Amesbury to Berwick Down

Public Consultation – February 2018

Name:	Mr Jim Carr			
Address:	1 Cleeve View	• • • • • • • • • • • • • • • • • • • •		
***************************************	Winterbourne Stoke			
	Salisbury			
	Wiltshire		Postcode: SP3 4SY	
Email:	clerk@winterbournestokepc.or	g.uk		
Are you an affected landholder:		☐ Yes	⊠ No	
Are you responding on behalf of an organisation:		¥ Yes	□ No	
If yes, which	organisation? Winterbourne Stok	e Parish Cou	ncil

Figure 1. PROW

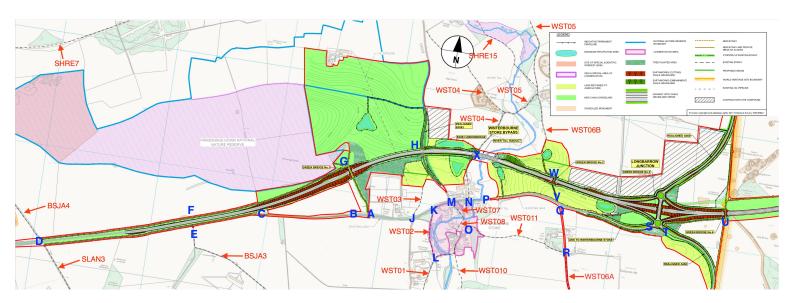
- A. The two new proposed byways from Yarnbury Castle to Winterbourne Stoke (G-F-D and D-E-C are most welcome. However, both should be Restricted byways (open to pedestrians, cyclists and equestrians.

- B. The Western edge of the scheme, defined by the ends of these two byways at Yarnbury Castle (D), should be delineated by a safe, north to south crossing of the A303 between byways SLAN3 and BSJA4. This is critical to allow civilian and military crossing to be made at this point (for military use of the grass airstrip immediately to the northwest of Yarnbury Castle) at Deptford Down. A safe crossing at this point is critical in joining byway networks to the north that run towards Wales and to Grovelly Wood and the Kings Way to the South which connect byway networks westward to Dorset and Devon. A green bridge would probably be inappropriate at this point (D) due to the terrain, but an underpass and vehicle pull off areas from the A303 on both carriageways should be considered. This would also allow circular routes between Winterbourne Stoke and Yarnbury, opening up a route exploitable for tourism and recreation.

- C. Concrete barriers should be placed across the route of the old A303 at point A

Cont: - on the map, to prevent vehicular access beyond point A towards B and C. Ideally, there would be a locking gate at point A to allow access by local farm vehicles only. We strongly oppose any suggestion that the route from the old A303 via A-B-C-E to BSJA3 should be open to HGVs to service the chicken farm south of the A303 on BSJA3. Access to this farm should be via BSJA3 from Berwick St James(B3083) and egress should be westwards from point E, joining the westbound A303 via a short slip-road at point D.

- D. The proposed Green Bridge No 1 should be abandoned and replaced with a simple bat-bridge to accommodate the flight lines of the Barbastelle bats. This would prevent points A and B becoming impromptu campsites for Travellers or encouraging the already too prevalent crime of Hare coursing. The layby at B should be dug up and the ground brought up to level with the existing A303. Access to fields at G, instead of being via Green Bridge 1 ((A-G), should instead be from the northern side of the B3083, wetwards from point H to point G.

- E. A temporary bridlepath from Winterbourne Stoke to Yarnbury should be implemented as part of an advance work package to minimise impacts on the livery at Scotland Lodge farm and on other local equestrians. Ideally, it would run from H to D via G and G and be accessible from the B3083.

- F. The entire route from C via AJ-K-M-N-P-Q to S, should be suitable for pedestrians, cyclists and equestrians. The suggestion it should only be for pedestrians and cyclists is unacceptable. From point A eastwards towards S, pedestrians, cyclists and equestrians will need to be seperated from vehicular traffic. From point P eastwards, the route for pedestrians, cyclists and equestrians should be on the southern side of the current A303, rather than the northern side as proposed by HE. The southern side is preferable as it already has wider grass verges and there would be no requirement for a crossing of the A303 at point S. This would further serve to reduce the amount of land taken from Manor Farm by a further 0.57h plus 0.18h.

- G. The existing layby at point B should be removed and the ground brought up to level with the existing A303. All tarmac between point A and C should be removed and returned to a gravelled track unsuitable for non-farm vehicles.

- H. Winterbourne Stoke Parish Council would be interested in making use of the land in the vicinity of point B for legacy purpose. Ideas that have already been mooted include a small village hall/ meeting room/changing room, a sports field, allotments and a village orchard.

- I. A small carpark could be provided for the Parsonage Down site at G. The short stretch of our proposed byway from H to G could be provided with a metalled surface to facilitate access to the carpark.

- K. Winterbourne Stoke Parish Council appreciate the need for a Western compound, but feel that its positioning on the B3083 is unnecessarily intrusive on the village and village life, let alone it being a further imposition on Manor Farm. We believe that this should be located further west at point F to the north of the new route and accessed by the haul road from point H. Alternatively, it could be located at point E to the south of the A303. This would necessitate improvement of BSJA3 to allow easy access, but this would be compatible with our proposals at 3C above and the advance work needed would be compatible with a long term solution.
